# Access Compliance Report

## Public Rights-of-Way

| Intersection ID: 28929                  | Main Street: WADE ARDREY RD | Cross Street: CAMPBELL HALL CT          | Location: SE           |
| ADA ID: BE124B8778E1                    | Ramp Type: Perp             | Initial Pass/Fail: Fail                 | Overall Compliance: No |

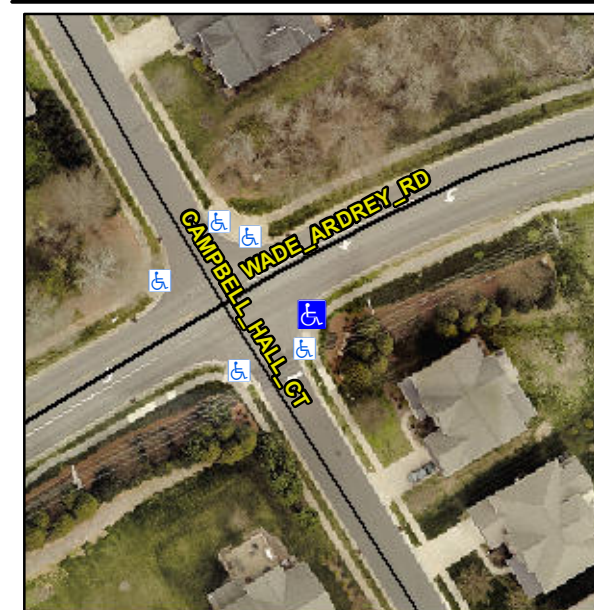
**Not Found, R304.2.2**

| Compliance | Description           | Data  | Compliance | Description                 | Data |
|------------|-----------------------|-------|------------|-----------------------------|------|
| N/A        | Ramp Length (in)      | 48.0  | No         | Ramp Slope (%)              | 8.6  |

**Remove & Replace Entire Ramp.**
